# TELECOMMUNICATIONS COMMITTEE

TUESDAY, JANUARY 8, 2019  
9:00 A.M.

DATE: January 3, 2019  
TO: Telecommunications Committee  
FROM: Planning Division  
SUBJECT: **WIRELESS TELECOM FACILITY (WTC17-00026) – LAURA CASTRO (J5 INFRASTRUCTURE PARTNERS)**

## WIRELESS PLANNING MEMORANDUM

Figure 4: Existing Verizon Coverage without the proposed site (Source: Verizon Maps)

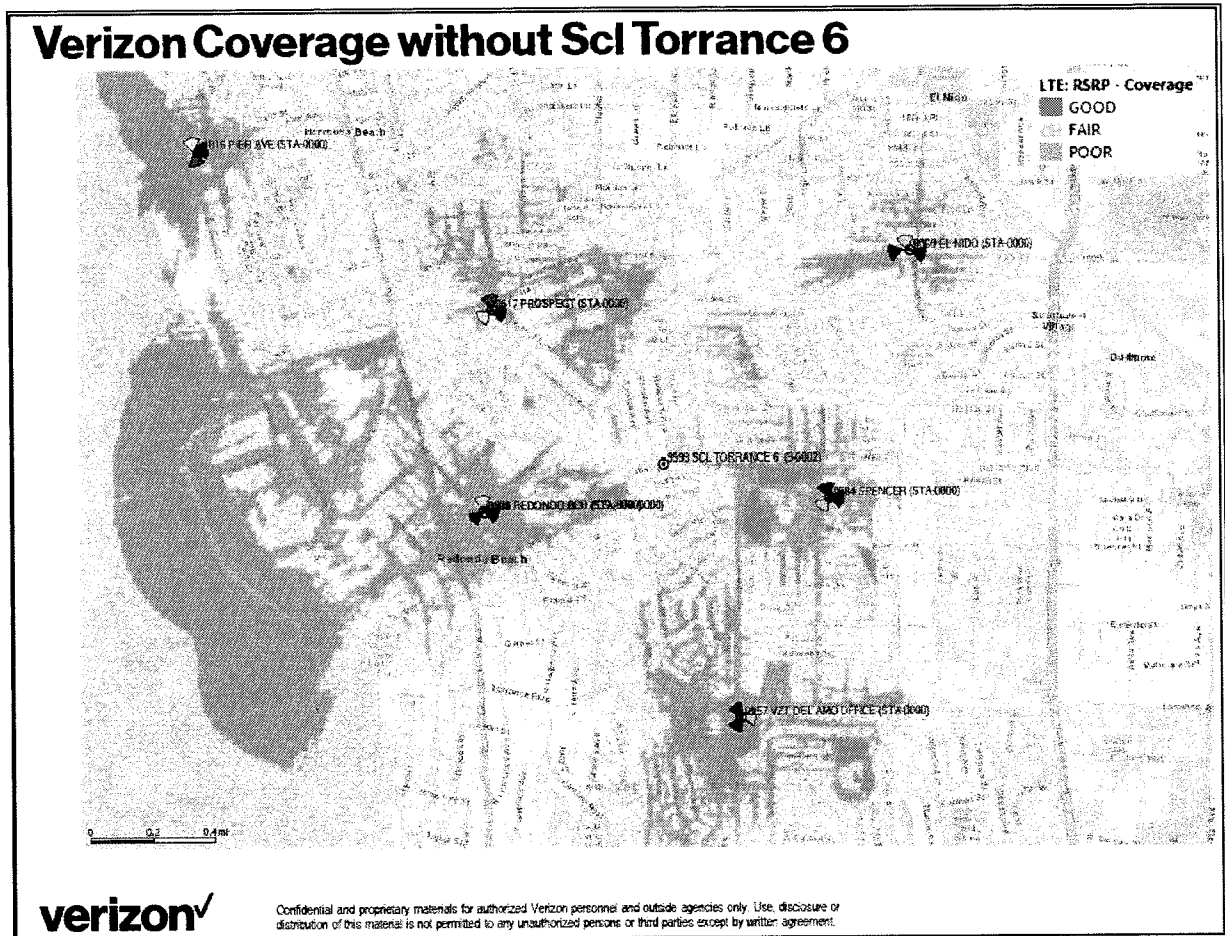
The propagation map reproduced in Figure 4 is a computer model of Verizon’s existing signal strength within the area based on a color-coded legend. Green indicates “Good” signal, yellow indicates “Fair” signal and purple indicates “Poor” signal. Without the proposed site, Verizon’s Map shows that the area surrounding the proposed site suffers from primarily “Poor” signal levels

with pockets of “Fair” signal levels. However, Verizon’s Maps contain subjective characterizations rather than empirical signal strength levels in dBm.

Figure 5: Proposed Verizon Coverage with the proposed site (Source: Verizon Maps).

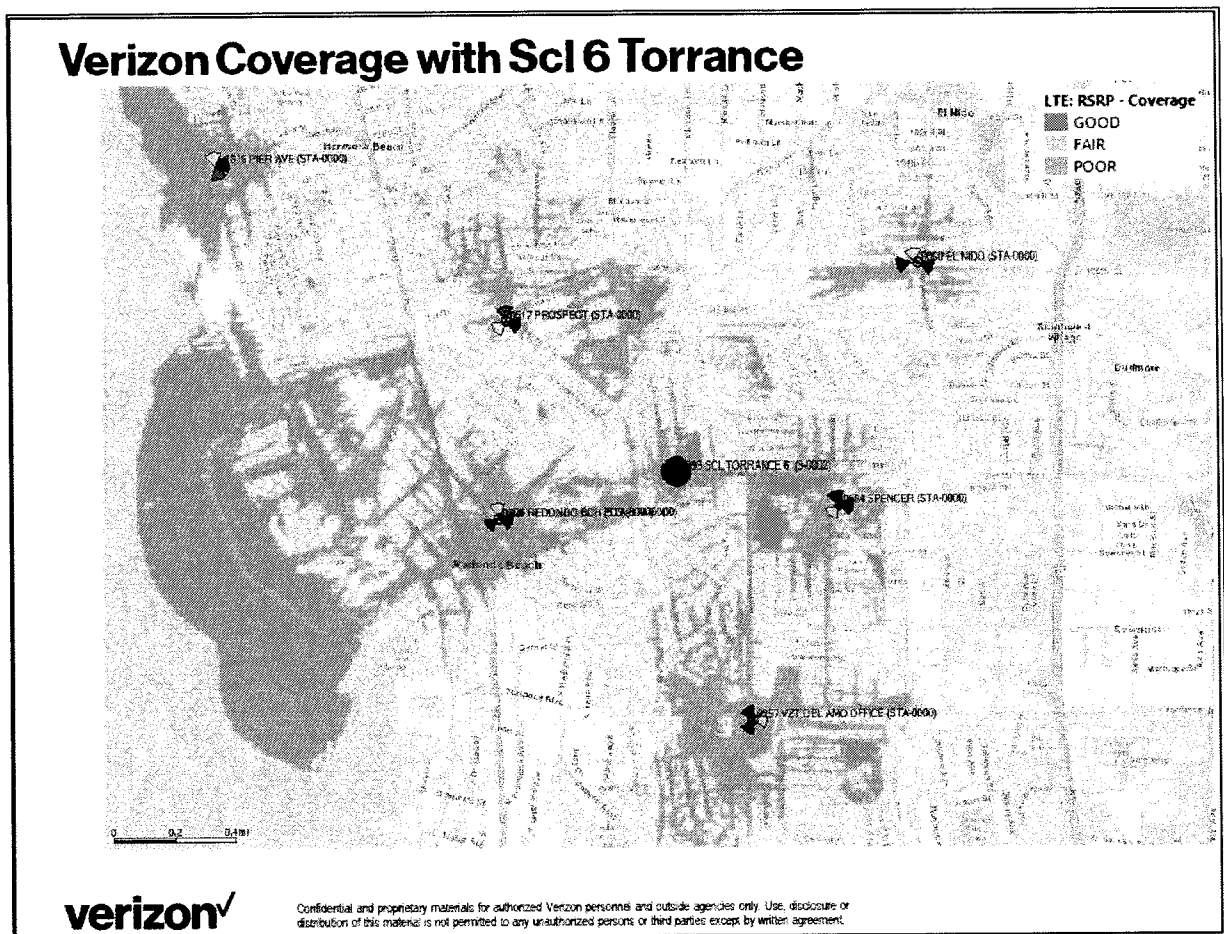
The Map submitted with the application and reproduced in Figure 5 models Verizon’s service coverage with the combined signals from the proposed and surrounding sites. Verizon’s proposed coverage depicts “Green” in all directions immediately around the proposed site. However, Verizon’s propagation maps provide only limited objective signal measurements for the proposed coverage area and do not provide sufficient context for assessing how the signal measurements and the color-coding relate to an inability to provide wireless services. Moreover, the application does not contain any empirical data to suggest that users experience dropped calls.

**Figure 6:** Proposed Pole and Recommended Lesser Intrusive Pole (Source: Google Maps, Annotated by Dr. Kramer).

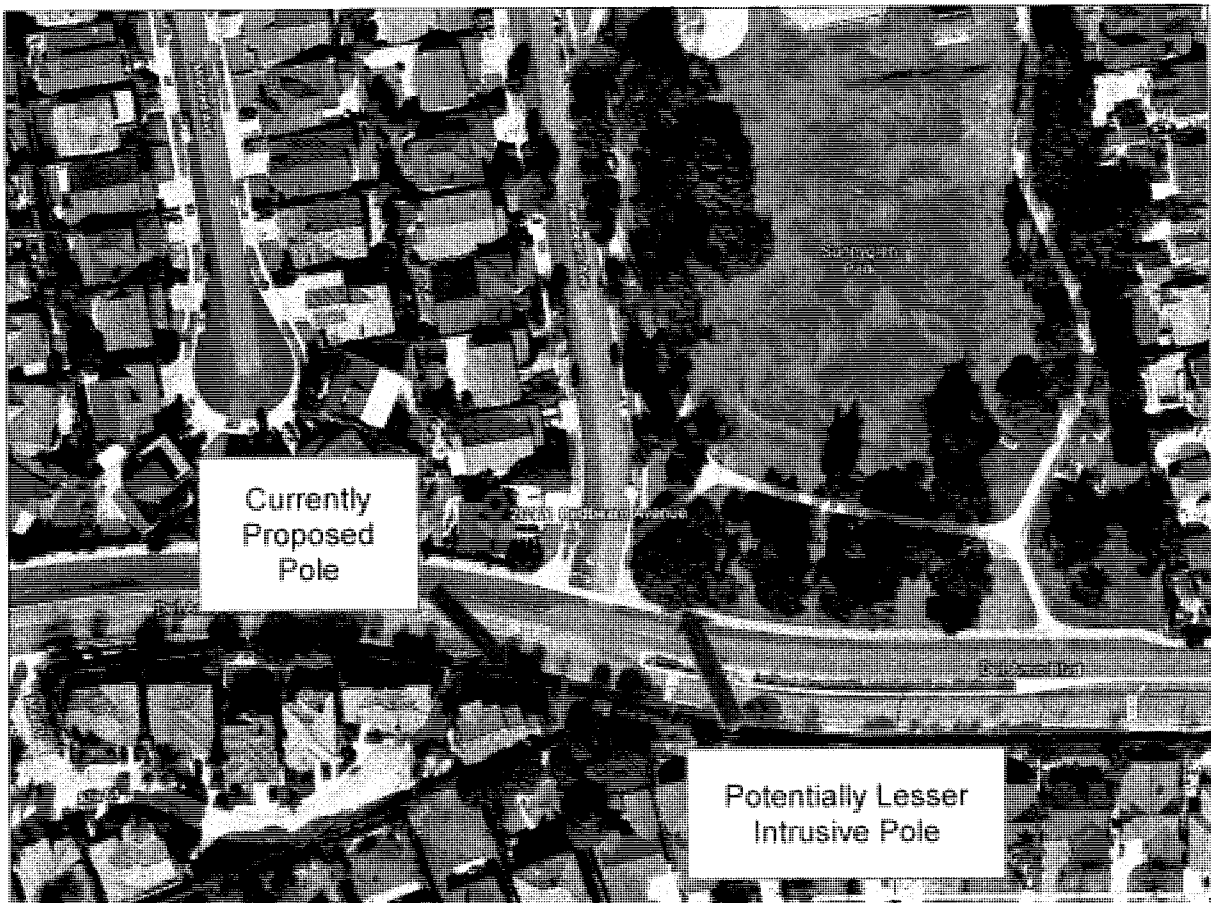
Based on a desktop review of the area surrounding the proposed location, TLF believes that the pole on the opposite side of the street to the East of the existing street light pole on Del Amo Boulevard appears to offer a meaningfully better aesthetic alternative in comparison to the proposed location. See Figure 6. The recommended pole, abuts Sunny Glen Park.

**Figure 1:** Antenna, Antenna skirt enclosing Diplexers, Fiber Node, 2 RRUs (Missing visual elements, e.g. RF signage, Fiber Pull Box, etc.) (Source: Photo Simulations provided by Applicant).

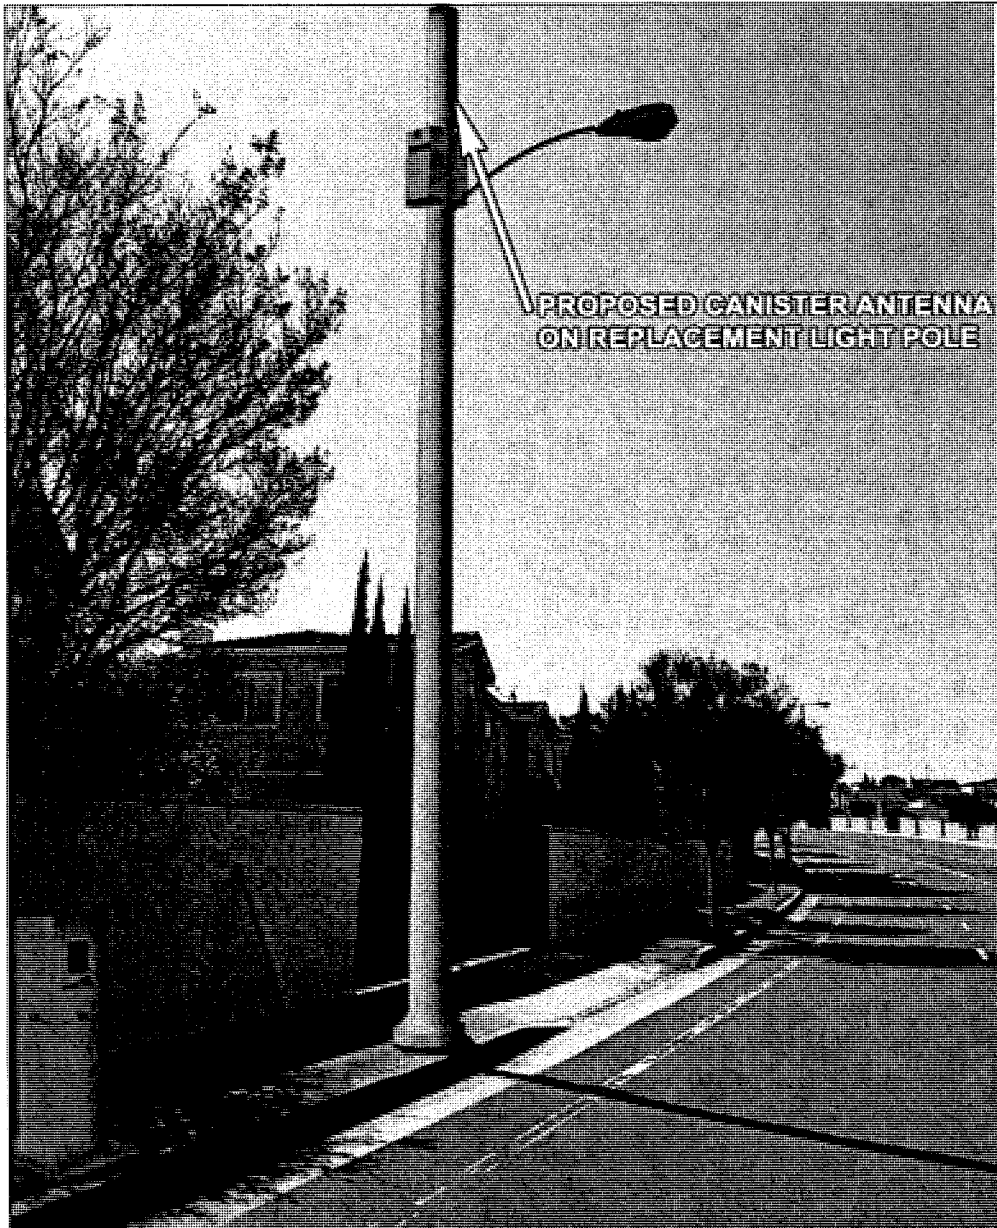
- Section 6.05 is not separately provided, however the Applicant provided an EBI RF Report. The EBI RF Report is a satisfactory substitute.
- Section 7.01–subsection 2: Missing elements on the photo simulations (e.g., RF signage, fiber pull box etc.) See Figure 1 below.

Figure 4: Existing Verizon Coverage without the proposed site (Source: Verizon Maps)

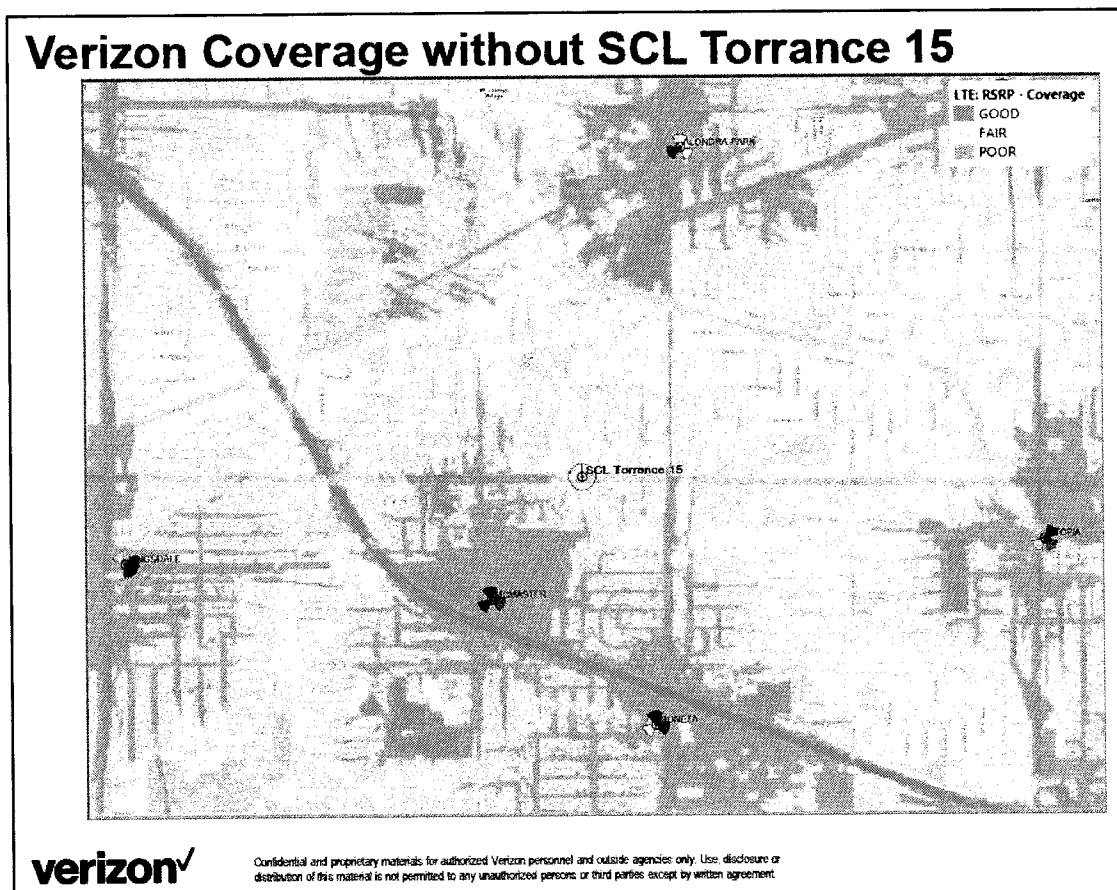
The propagation map reproduced in Figure 4 is a computer model of Verizon’s existing signal strength within the area based on a color-coded legend. Green indicates “Good” signal, yellow indicates “Fair” signal and purple indicates “Poor” signal. Without the proposed site, Verizon’s

Map shows that the area surrounding the proposed site suffers from primarily “Poor” signal levels with pockets of “Fair” signal levels. However, Verizon’s Maps contain subjective characterizations rather than empirical signal strength levels in dBm.

Figure 5: Proposed Verizon Coverage with the proposed site (Source: Verizon Maps).

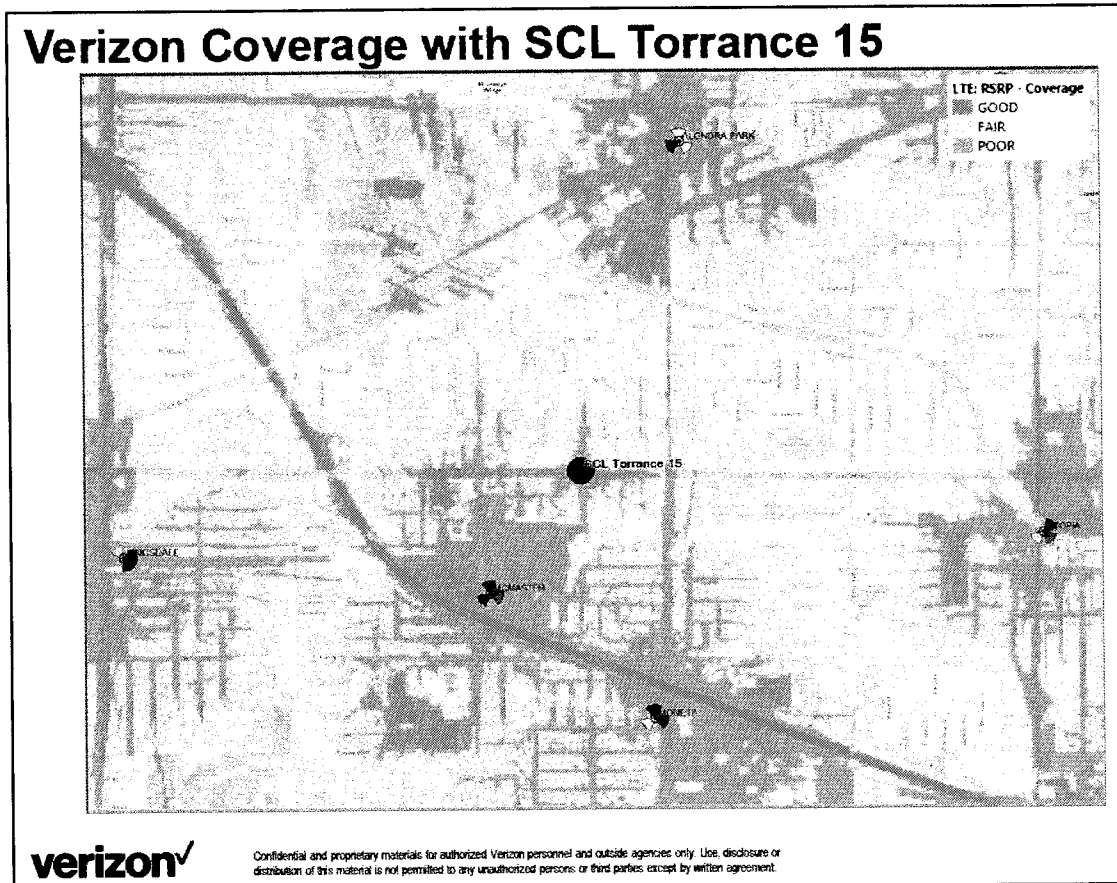
The Map submitted with the application and reproduced in Figure 5 models Verizon’s service coverage with the combined signals from the proposed and surrounding sites. Verizon’s proposed coverage depicts “Green” in all directions immediately around the proposed site. However, Verizon’s propagation maps provide only limited objective signal measurements for the proposed coverage area and do not provide sufficient context for assessing how the signal measurements and the color-coding relate to an inability to provide wireless services. Moreover, the application does not contain any empirical data to suggest that users experience dropped calls.

Figure 6: Proposed Pole and potential lesser intrusive pole location (Source: Google Maps, Annotated by Dr. Kramer).

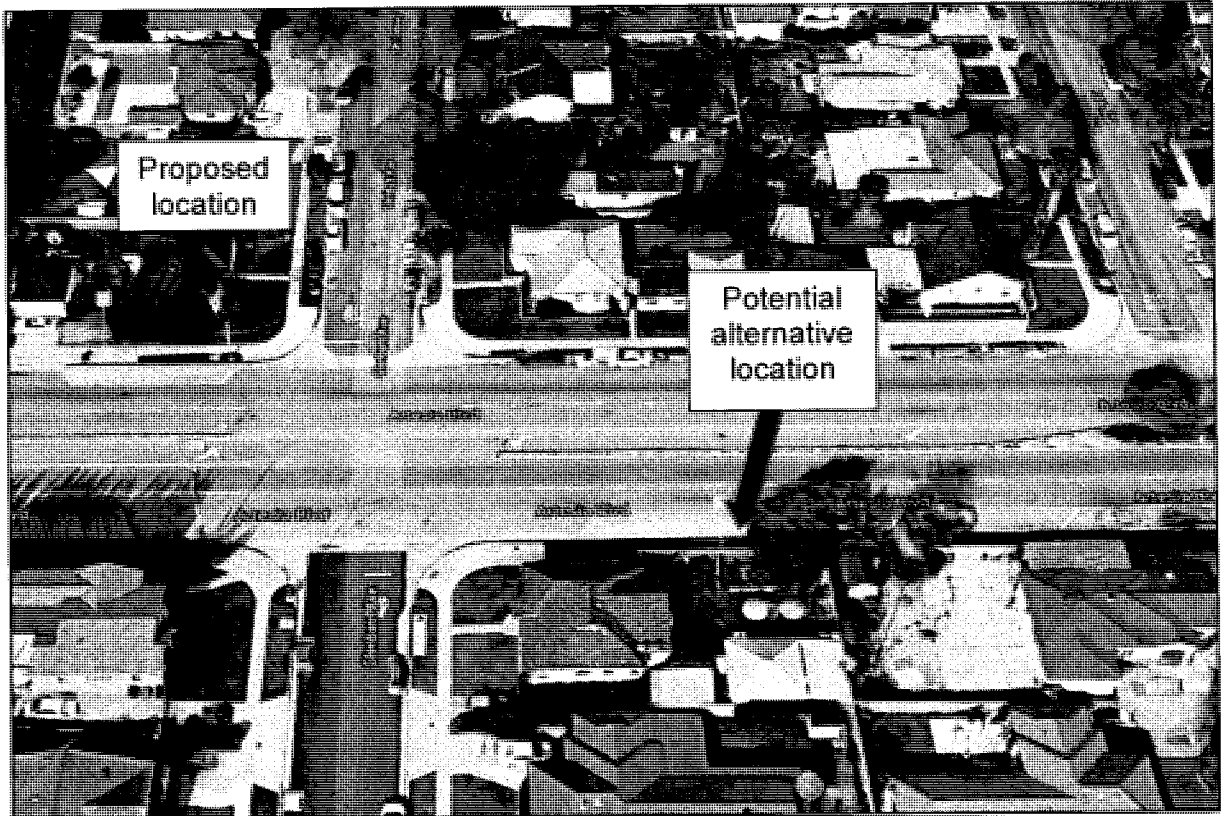
Based on a desktop review of the area surrounding the proposed location, TLF believes that the pole on the opposite side of the street to the East of the existing street light pole on Artesia Boulevard appears to offer a meaningfully better aesthetic alternative in comparison to the proposed location. See Figure 6. The recommended pole is at the back side of a residence.

**Figure 1:** Antenna, Antenna skirt enclosing Diplexers, Fiber Node, 2 RRUs (Missing visual elements, e.g. new Pole location, RF signage, fiber pull box, connecting cables, etc.) (Source: Photo Simulations provided by Applicant).

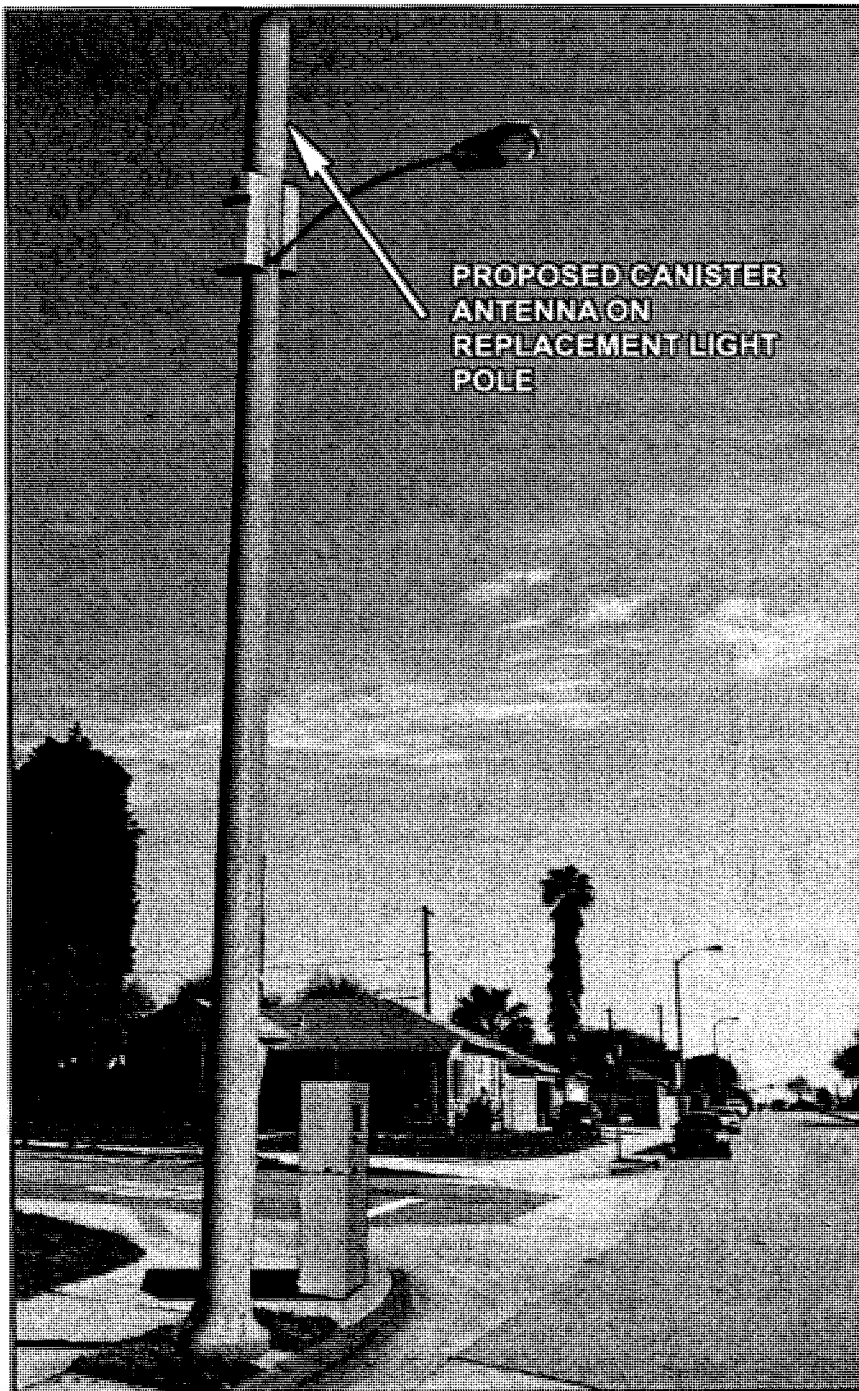
- Section 6.05 is not separately provided, however the Applicant provided an EBI RF Report. The EBI RF Report is a satisfactory substitute.
- Section 7.01 – subsection 2: Missing elements on the photo simulations (e.g., new Pole location, RF signage, fiber pull box, connecting cables, etc.) See Figure 1 below.

Figure 5: Proposed Verizon Coverage with the proposed site (Source: Verizon Maps).

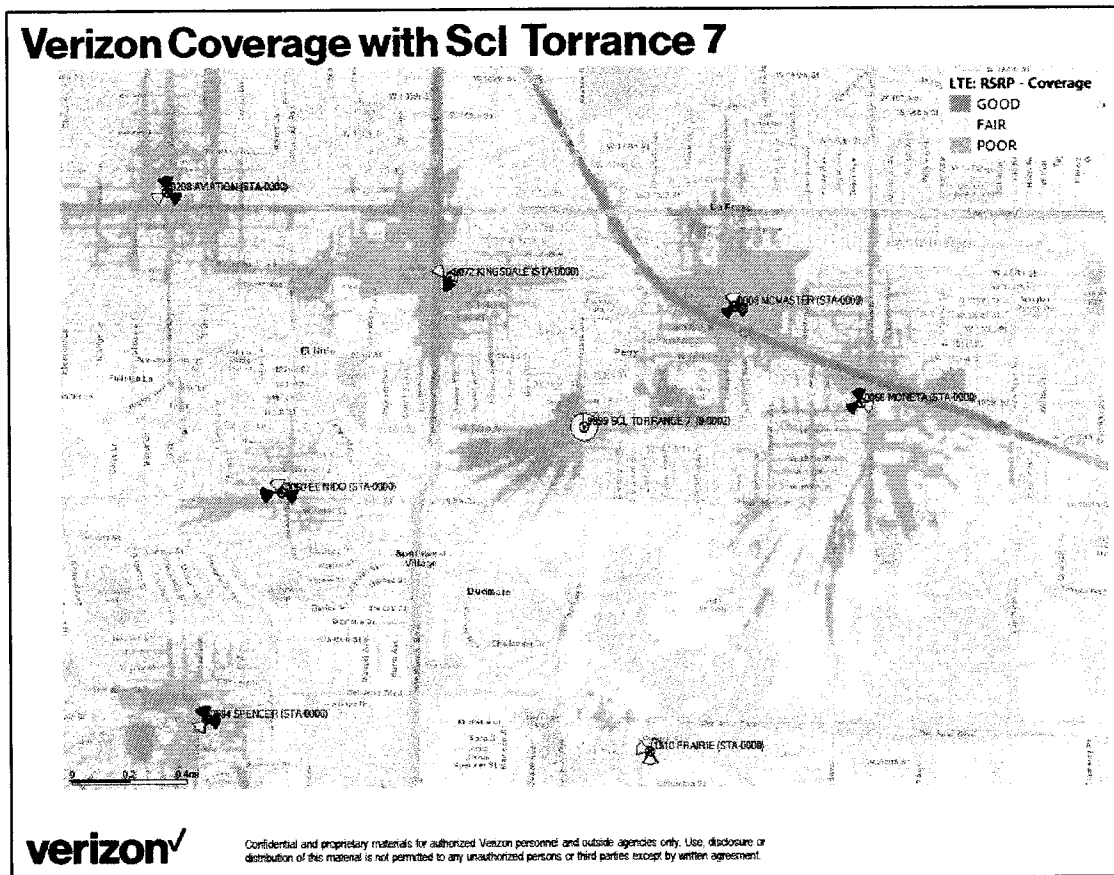
The Map submitted with the application and reproduced in Figure 5 models Verizon’s service coverage with the combined signals from the proposed and surrounding sites. Verizon’s proposed coverage depicts “Green” in all directions immediately around the proposed site. However, Verizon’s propagation maps provide only limited objective signal measurements for the proposed coverage area and do not provide sufficient context for assessing how the signal measurements and the color-coding relate to an inability to provide wireless services. Moreover, the application does not contain any empirical data to suggest that users experience dropped calls.
